# Project Scope

D03 LG FY2027(A)

## Lighting

MED - SR83 - (0.942-0.963)

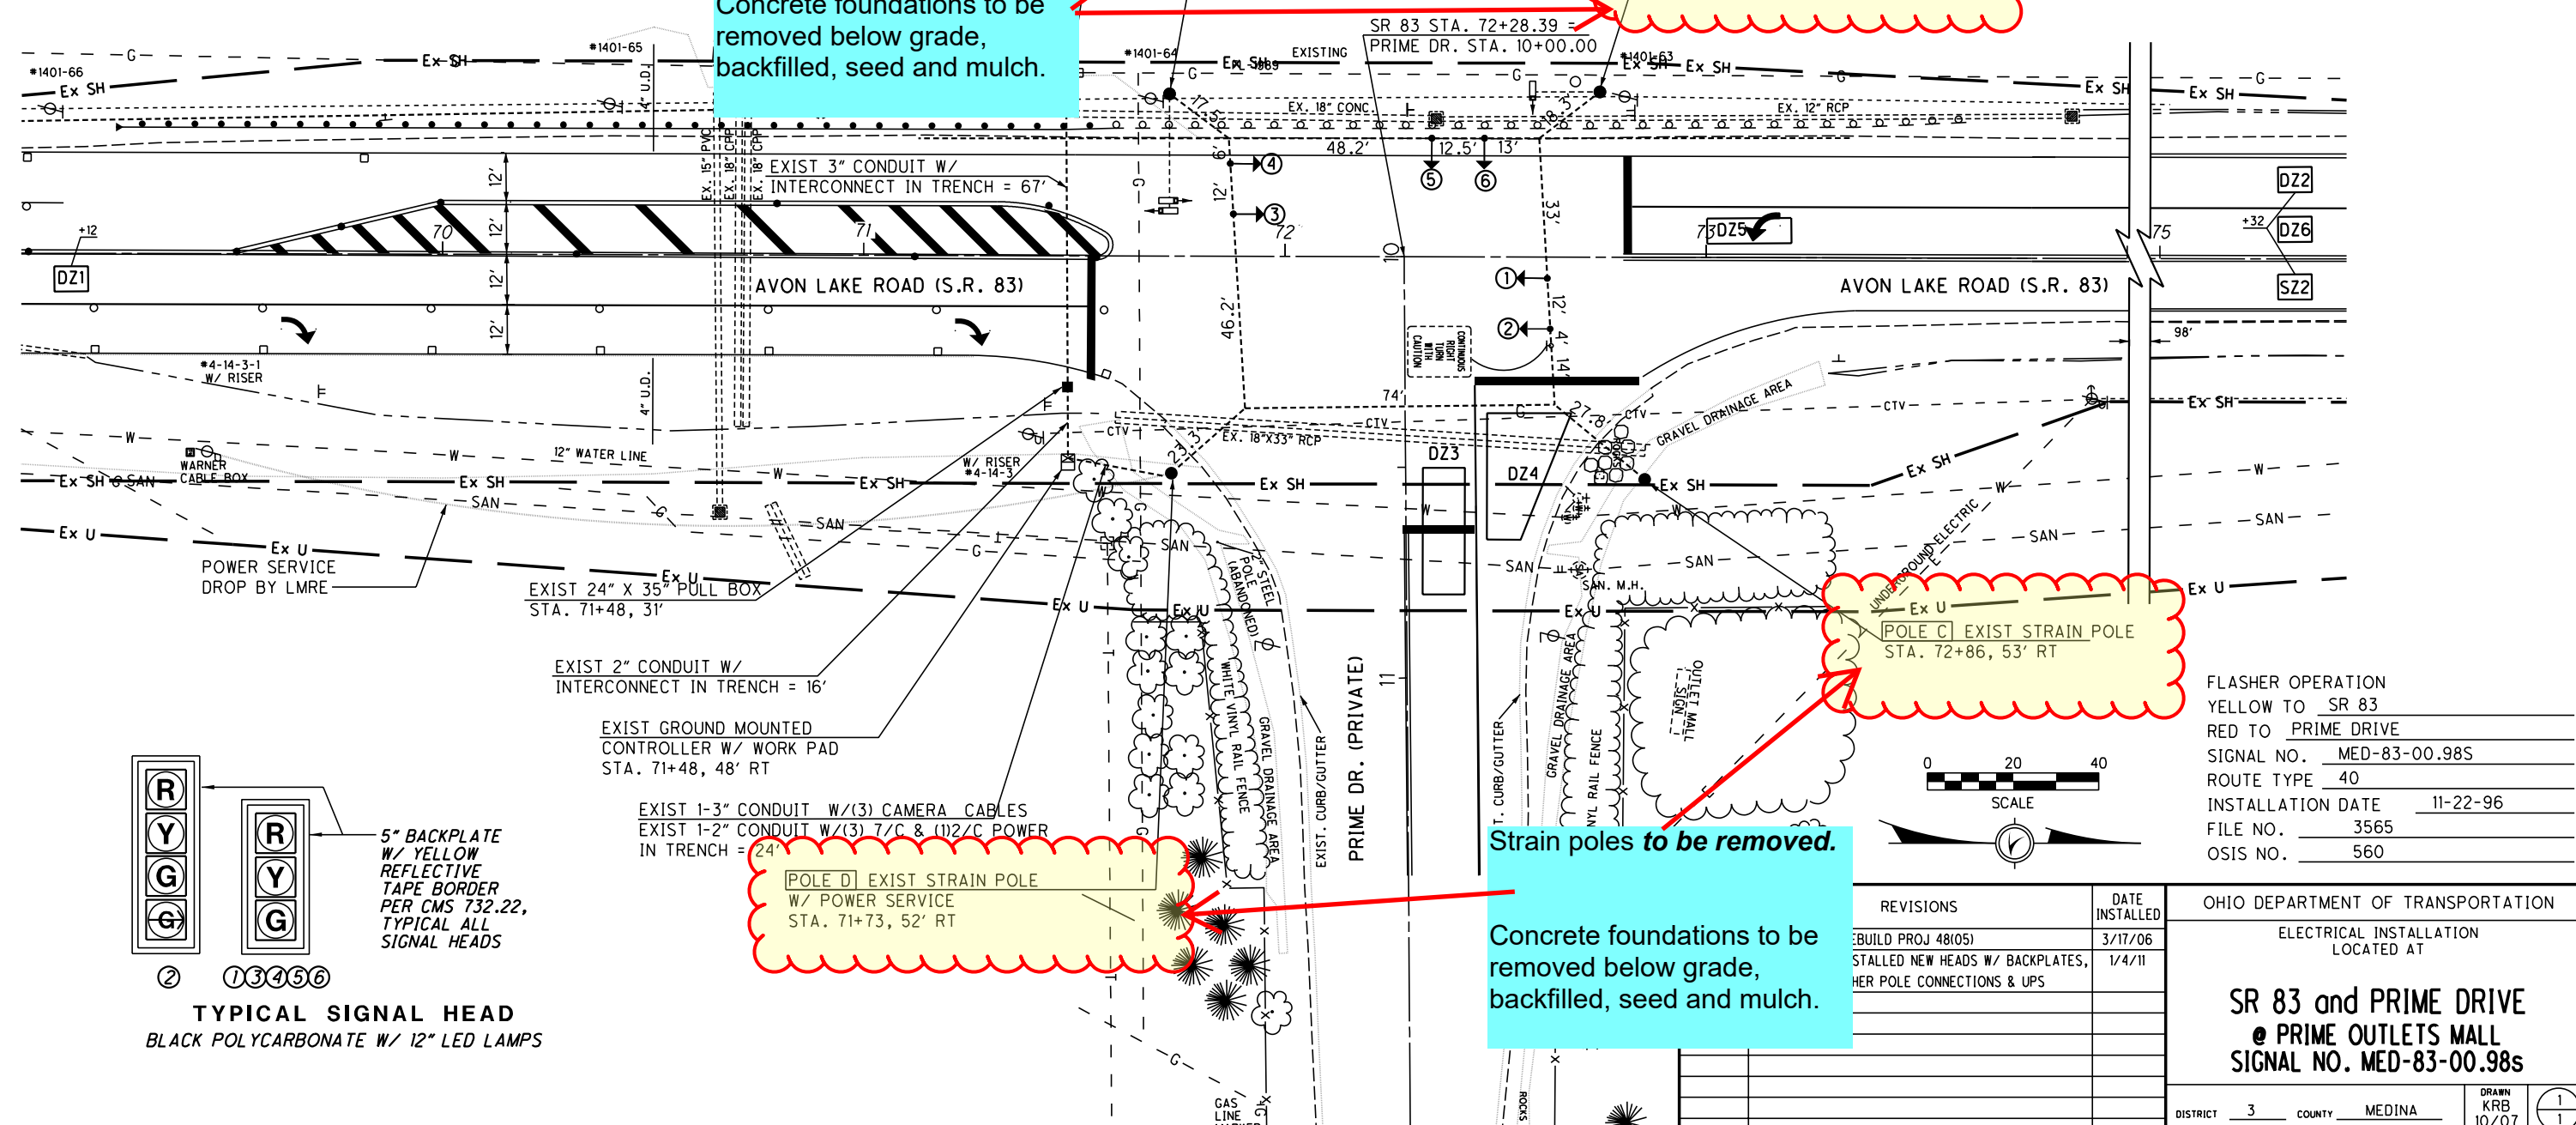
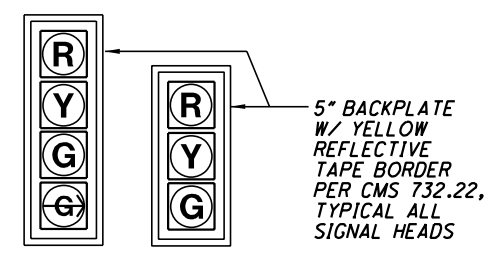
Strain poles have been removed already.

Concrete foundations to be removed below grade, backfilled, seed and mulch.

Strain poles to be removed.

Concrete foundations to be removed below grade, backfilled, seed and mulch.
